Intersection ID: 4268	Main Street: VOELTZ_DR	Cross Street: TWIN_DR	Location:	SE
ADA ID: 06B2F1D75BBD	Ramp Type: Perp	Initial Pass/Fail: Fail	Overall Compliance: No	Severity Score: 58.75

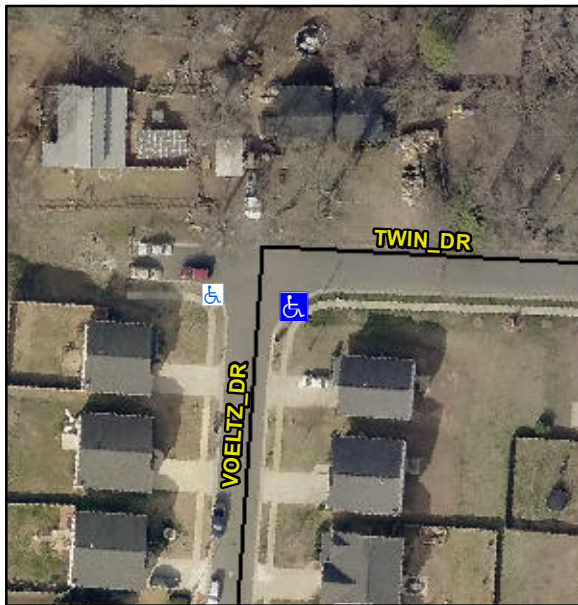
**Not Found, R304.5.1, R304.2.2,  
R304.5.3**

Possible Solutions:			Compliance	Description	Data	Compliance	Description	Data		
<b>Remove &amp; Replace Entire Ramp.</b>			N/A	Ramp Length (in)	46.5	No	Ramp Slope (%)	13.3		
			No	Ramp Width (in)	47.0	No	Ramp XSlope (%)	7.6		
			N/A	Flare Type LT	N/A	N/A	Flare Type RT	N/A		
			N/A	Flare Slope LT (%)	N/A	N/A	Flare Slope RT (%)	N/A		
			N/A	Flare Traversable LT?	N/A	N/A	Flare Traversable RT?	N/A		
			N/A	Landing Length (in)	N/A	N/A	DWS Provided?	N/A		
			N/A	Landing Width (in)	N/A	N/A	DWS Contrast?	N/A		
			N/A	Landing Slope (%)	N/A	N/A	DWS Length (in)	N/A		
			N/A	Landing X Slope (%)	N/A	N/A	DWS Full Width?	N/A		
			N/A	Landing Curb? (Y/N)	N/A	N/A	DWS Offset (in)	N/A		
Surveyor Notes: <b>N/A</b>			N/A	Shared Landing?	N/A					
			N/A	Gutter Ponding?	N/A	N/A	Gutter Slope (%)	N/A		
			N/A	Gutter Lip Ht (in)	N/A	N/A	Gutter X Slope (%)	N/A		
			N/A	Painted X Walk1?	No	N/A	Painted X Walk2?	N/A		
				X Walk 1 Direction	To W		X Walk 2 Direction	N/A

N/A	X Walk 1 Width (in)	N/A	N/A	X Walk 2 Width (in)	N/A		
				X Walk 1 Slope (%)	2.9		X Walk 2 Slope (%)	N/A		
				X Walk 1 X Slope (%)	6.4		X Walk 2 X Slope (%)	N/A		
			N/A	Ramp inside XWalk1?	N/A	N/A	Ramp inside XWalk2?	N/A		
				Road Slope (%)	N/A	N/A	Clear Space?	N/A		
PROW/ADA: <b>Not Found, R304.5.1, R304.2.2, R304.5.3</b>				Road X Slope (%)	N/A	N/A	Clear Space to XWalk (in)	N/A		
			N/A	Any Obstructions?	N/A	N/A	Storm Grate/Utility Hazard?	N/A		
				Obstruction Type			Storm Grate/Utility Type			
					N/A			N/A		
						Yes	Surface Condition? (G/P)	Good		
			Total Cost:			\$	1850.00

### Remove & Replace Entire Ramp.
